Re: Biosolids Pelletization Facility (BPF) – Train #1 & #2 Sludge Chutes
North County Resource Recovery Facility
Title V Air Operating Permit 0990234-022-AV

Justification for Enlarging Sludge Chutes From Weigh Belts to Mixer feed Screws

SECTION A
 LOOKING SOUTH @ 1.5 9GA1

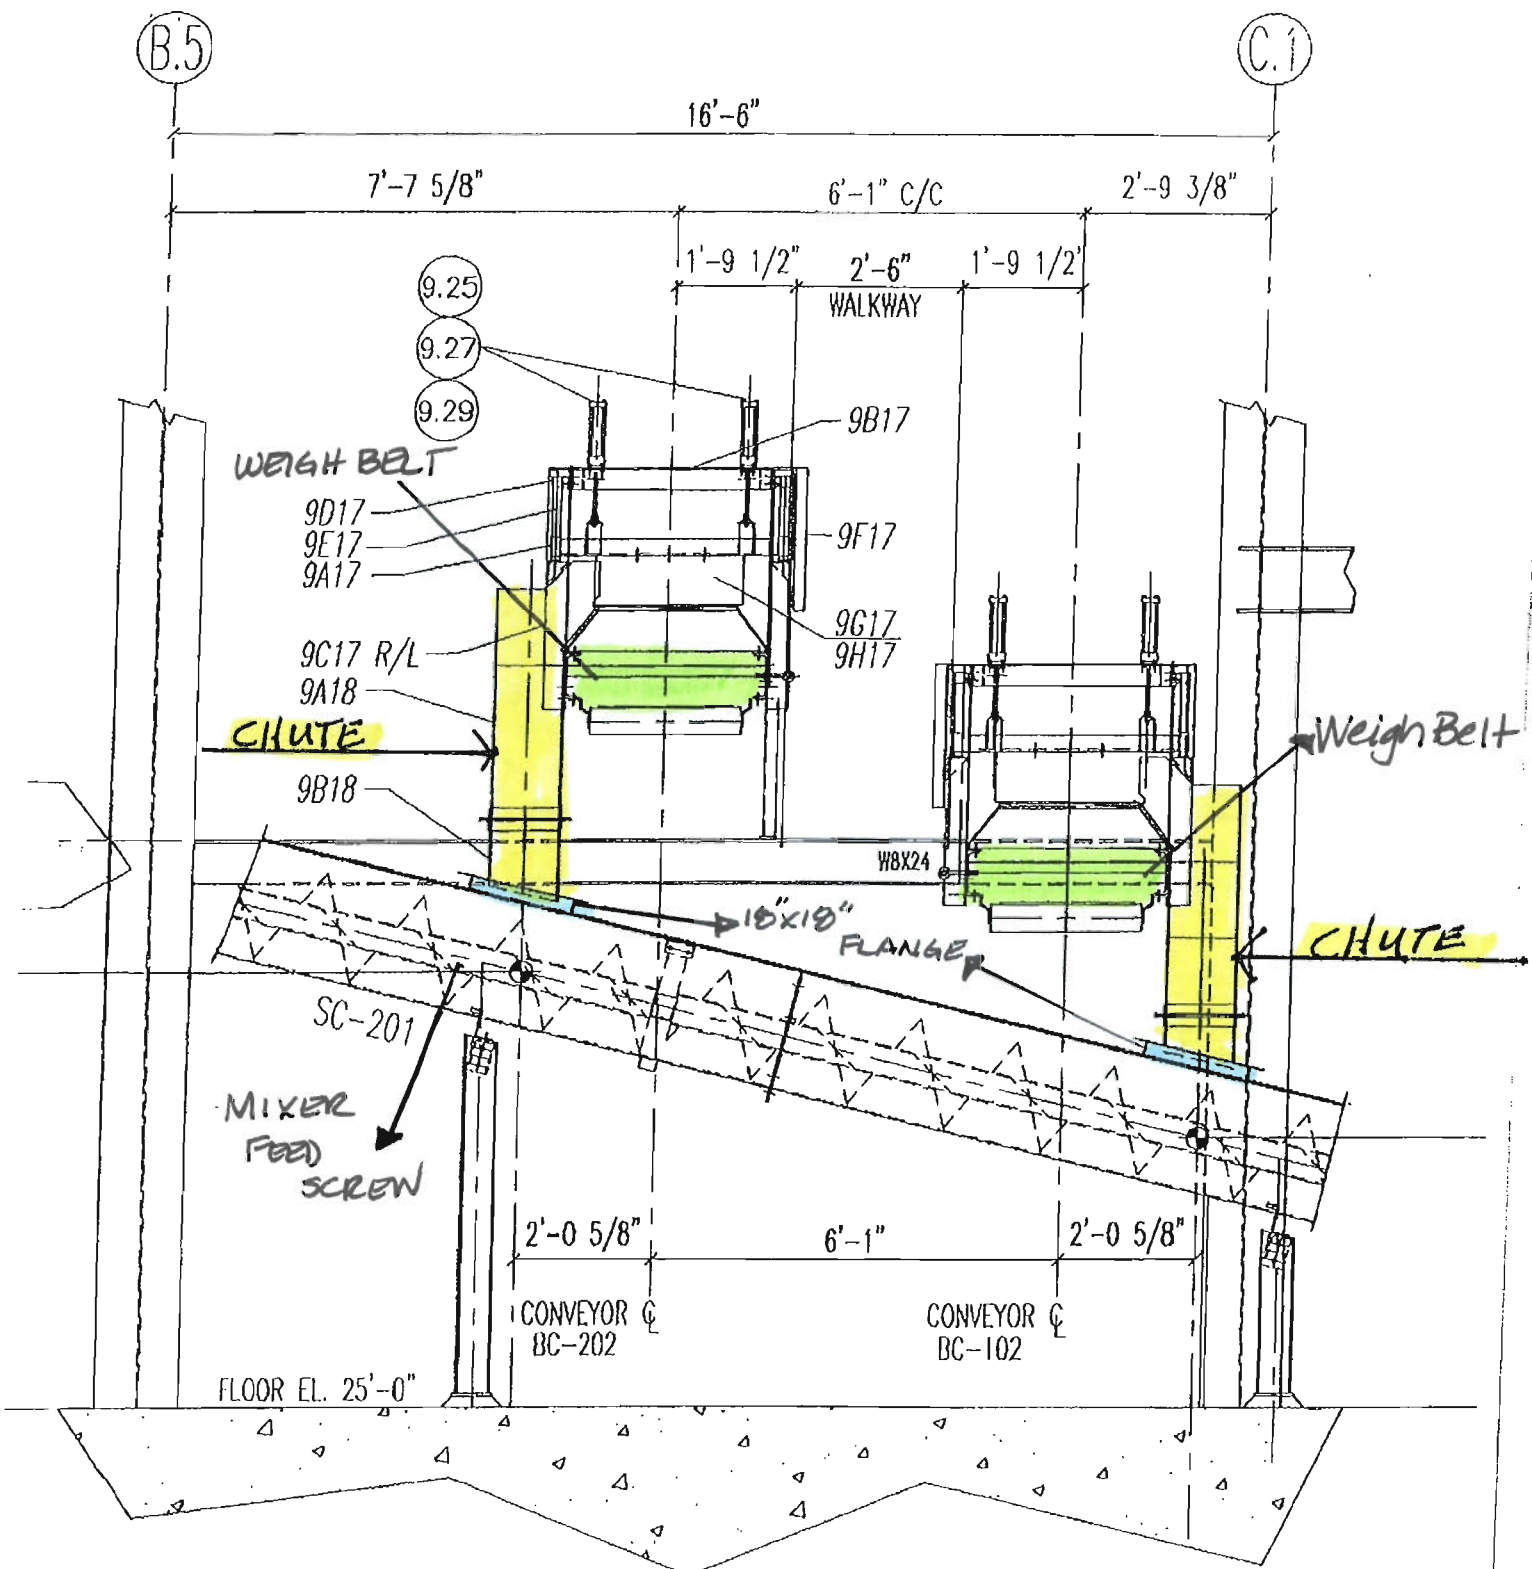
- The Sludge Chutes transfer the weighed sludge via gravity from the weigh belt to the mixer feed screw. See attached drawings for both Trains (dwg # A-9GA1 & B-9GA1).

- Existing chutes (two per train) dimensions are currently 18 inches by 12 inches.
- The flange inlet to mixer feed screws are 18 inches by 18 inches. See attached drawing (drw # 10 GA1).

- The purpose of enlarging the chutes on one side by 6 inches is to prevent sludge from plugging or bridging in the chutes and to match the 18 inch by 18 inch flange dimension on the mixer feed screw. The existing 12 inch chute dimension doesn't match the 18 inch flange mounted on the mixer feed screw and has caused sludge to bridge or plug in the chute. When the sludge bridges or plugs in the chute it will result in the sludge backing-up and causing a disruption to the process and for the process to be shutdown.
